REGIS HOMES
 THE ISLANDS AT RIVERLAKE

PLAN 7110
 EXTERIOR ELEVATION "A"
 Pocket Road

ISLANDS AT RIVERLAKE EIR QUESTIONS:

Partial Site Plan
LOT 22 of Parcel 4 at Riverlake
Scale 1/8"

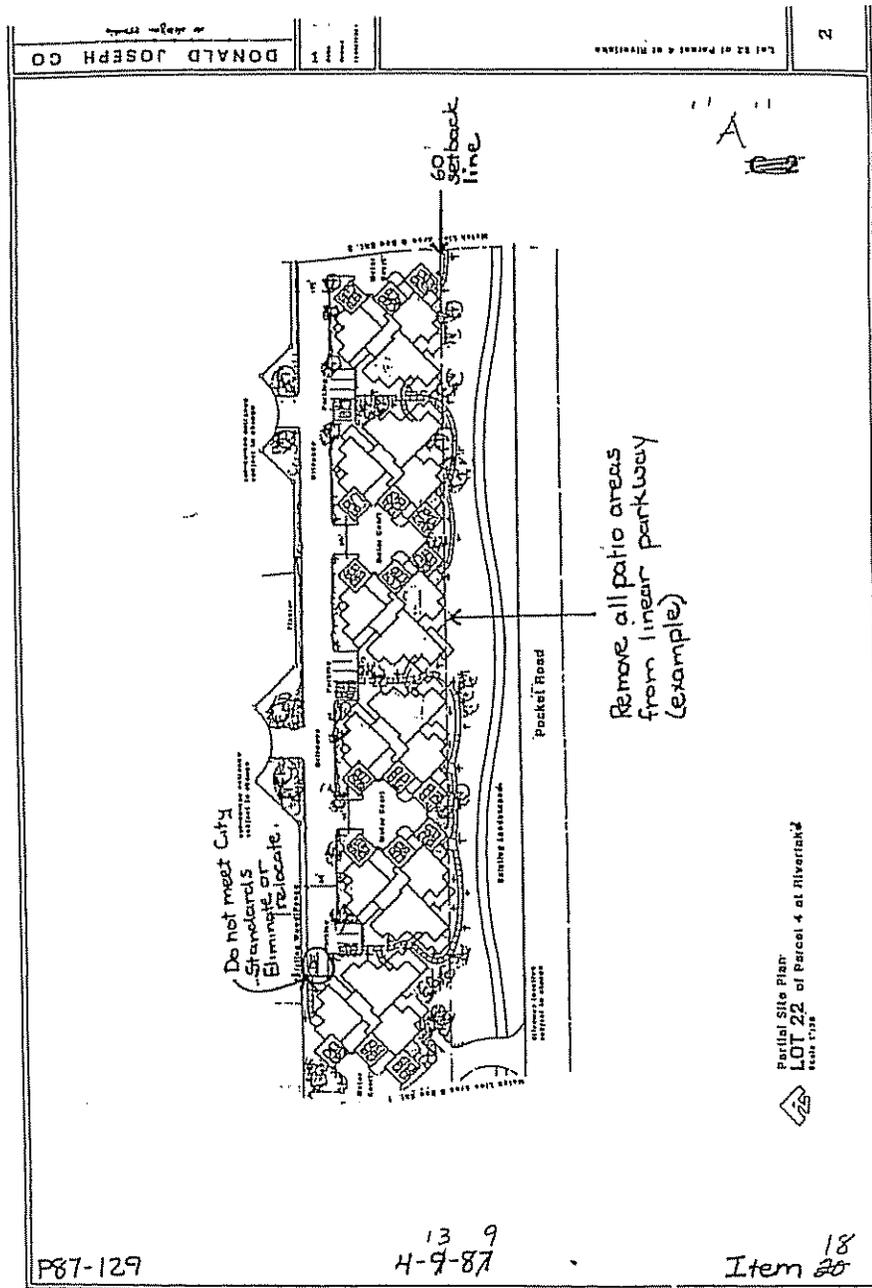
Remove all patio areas from linear parkway (example)

EXHIBIT "B"
1 OF 2

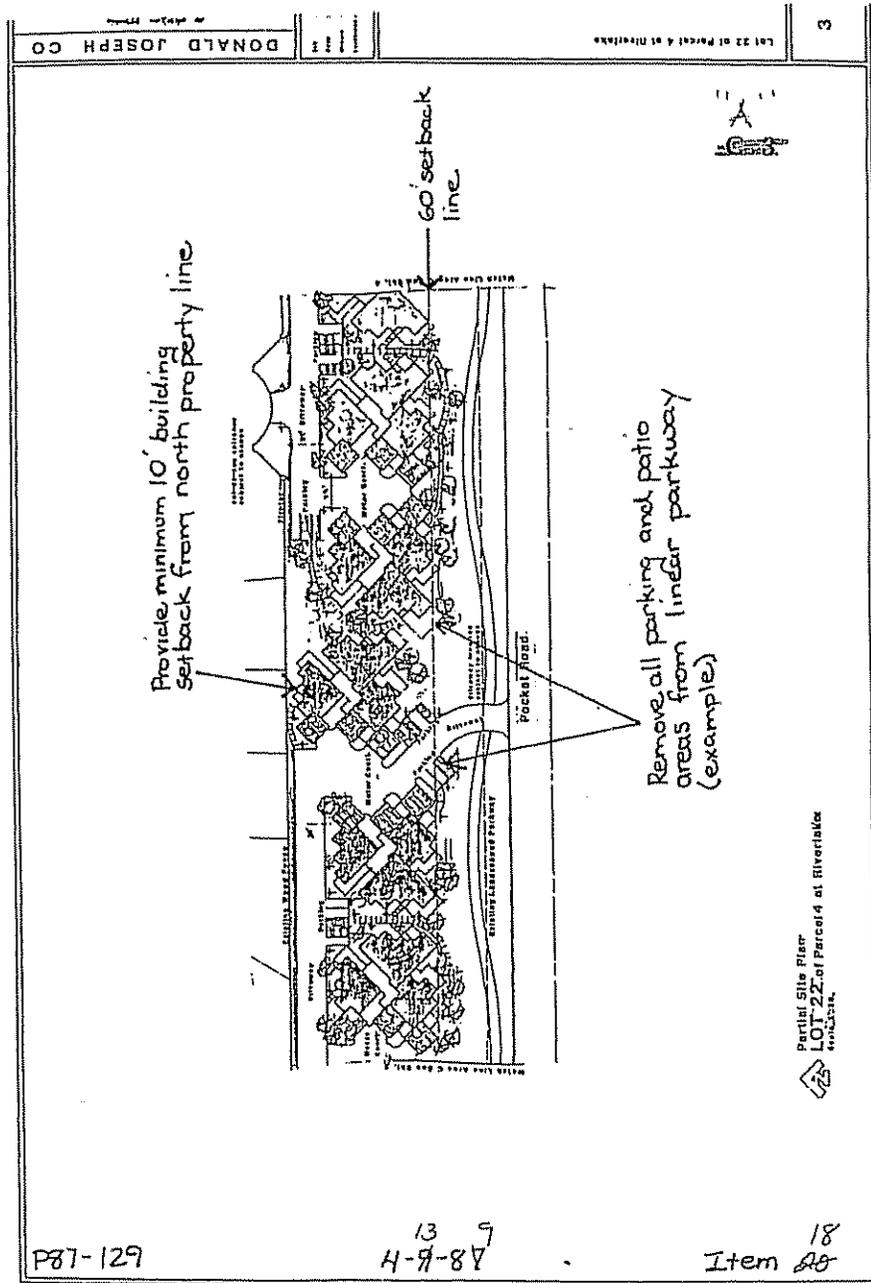
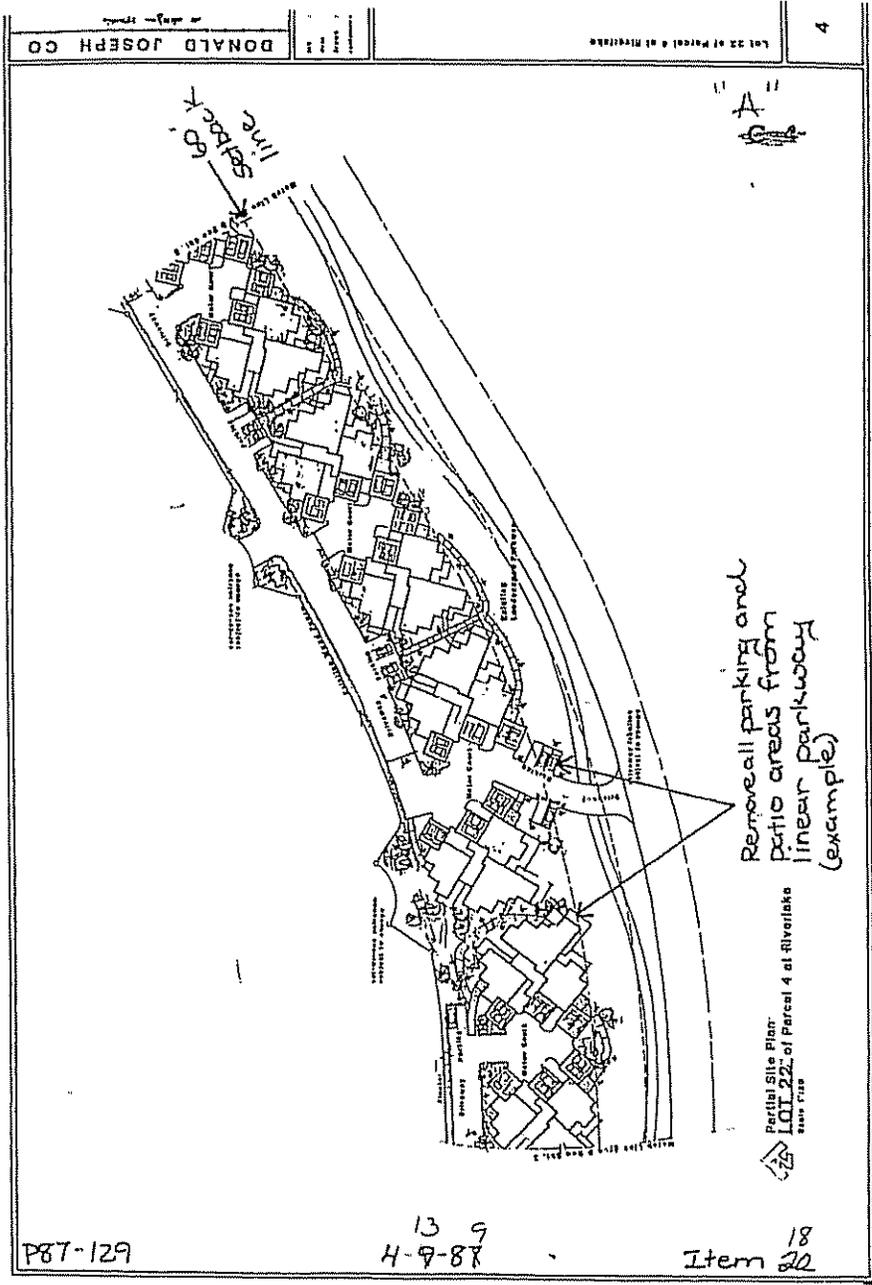
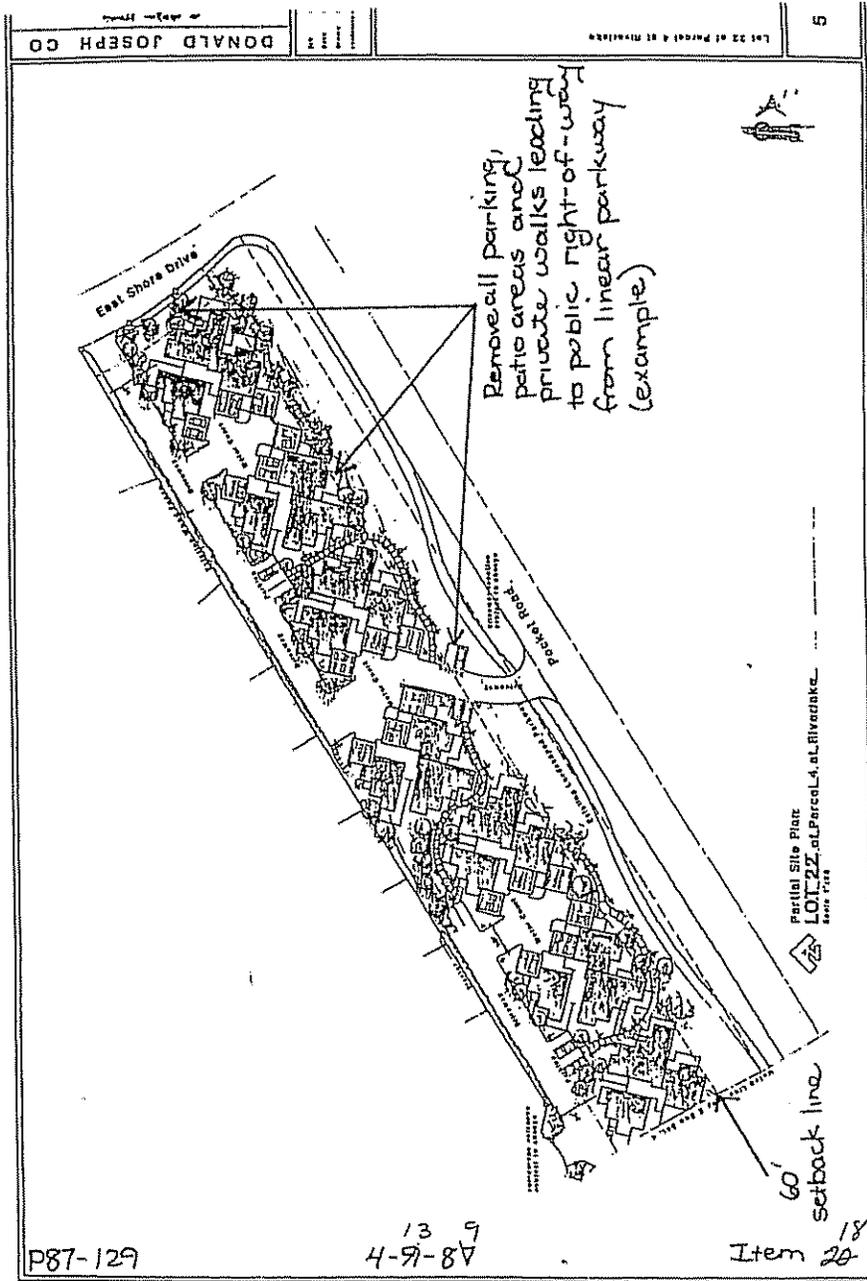
Attached as an exhibit is a City of Sacramento Planning Dept acreage analysis and resulting density calculations for your review. This analysis does not match up with data in the DEIR document, which allows readers to draw the wrong conclusions relative to density and impact to the community and is a major discrepancy.

The DEIR documents indicate a net acreage of 19.44 acres. The City Planning Department documented density factors for a January 27, 2003 community meeting indicates a net acreage of 12.23 net acres. What has been noted throughout the DEIR report indicating a density of 7.15 units per net acre. Isn't true that with a discrepancy of this magnitude many of the conclusions with reference to community impact are totally incorrect?

- 37-8 The net acreage was calculated consistently with Sacramento City Code 17.16.010 for the February 2005 Initial Study, the June 2005 DEIR, and the August 2005 FEIR. Please see Master Response 5. The sizes of the legal parcels were measured using AutoCAD functions. The gross acreage of the legal parcels is 21.44 acres. The ± 2-acre parkway easement to the City was subtracted from the gross acreage, in accordance with the definition of "net lot area"

in Sacramento City Code 17.16.010. Therefore, the resulting net acreage is 19.44 acres. When the LPPT PUD was approved, the gross acreage of the legal parcels was \pm 22.6 acres. The \pm 2-acre City parkway easement was subtracted for the resulting net acreage of 20.5 acres. The LPPT PUD Schematic Plan Map, which reports 20.6 acres for the project site, did not include the City parkway easement acreage. Since the LPPT PUD was approved, the gross and net acreage of Lot 21 was reduced due to a lot split for Dutra House and the public Dutra Bend Drive.

The formulation of net acreage presented in the 27 January 2003 meeting notes subtracted the acreage of the private street and the applicant-owned, Riverlake Community Association-held, landscape easement in addition to the acreage of the 25-foot wide parkway easement to the City. The formula for calculating net acreage in Sacramento City Code 17.16.010 does not subtract private roads and private easements. Therefore, the formulation of net acreage presented in the 27 January 2003 meeting was incorrect. The formulation of net acreage used in the 2005 Initial Study and EIR is the correct one.
